WILLIAMSON COUNTY, TEXAS

CHANGE ORDER NUMBER: 7

**FM3349 at US 79
Williamson County Project No. 22IFB139**

US 79 AND FM 3349 INTERSECTION IMPROVEMENT PROJECT
HUTTO EDC SOUTHBOUND FRONTAGE ROAD RIGHT TURN LANE
TAYLOR, TX

PLAN AND PROFILE
SBFR
STA 2481+00 TO STA 2492+00

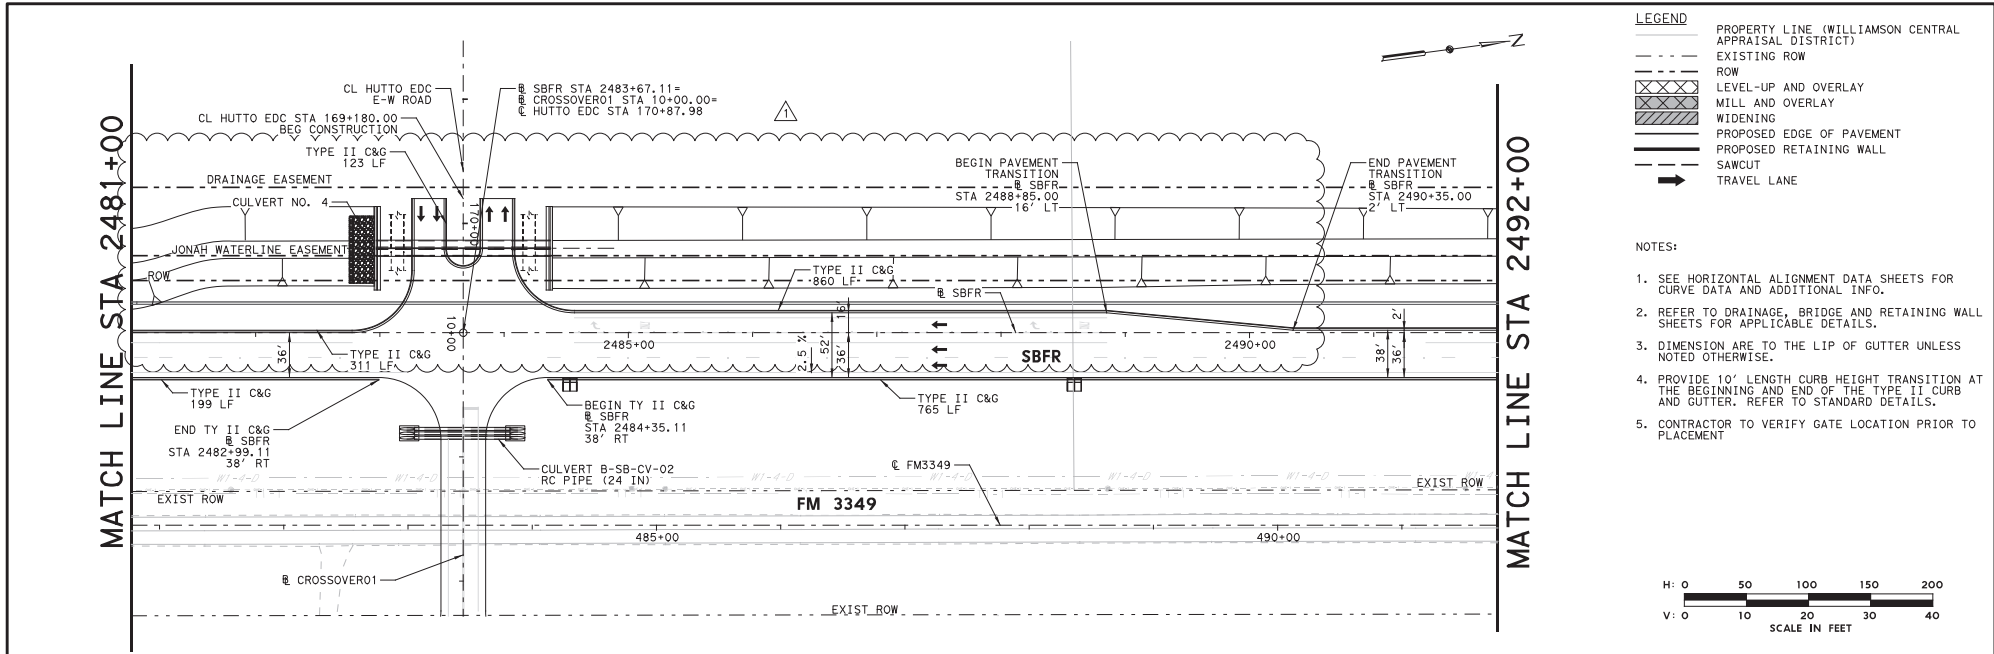
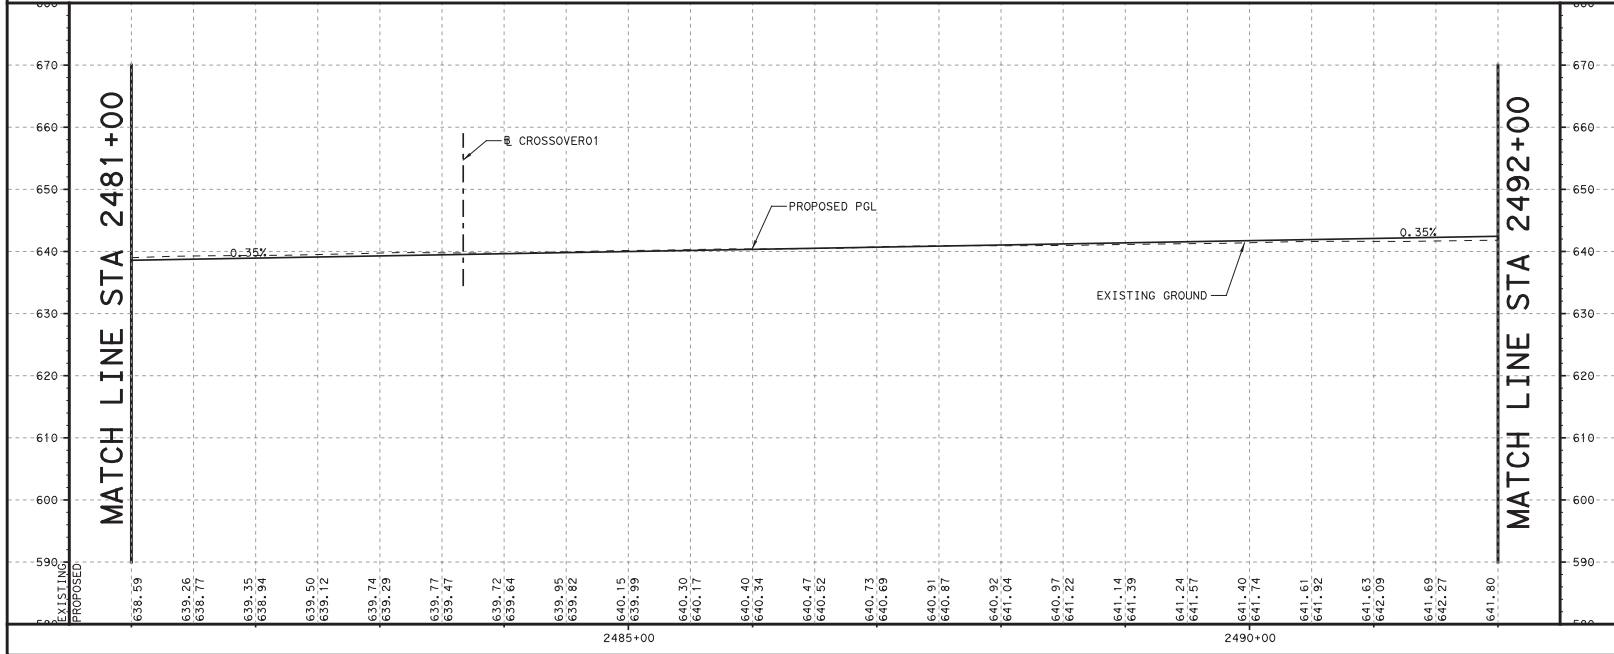
3F. Additional work desired by the County : This Change Order compensates the contractor for constructing the right turn lane of the southbound frontage road at FM3349 and Hutto Mega Site intersection. This work was requested and is 100% reimbursable by the Hutto Economic Development Corporation, Type B.

7. New or revised plan sheet(s) are attached and numbered: 197, 230, 346, 353-355, 374A, 401, 449A-C, 642
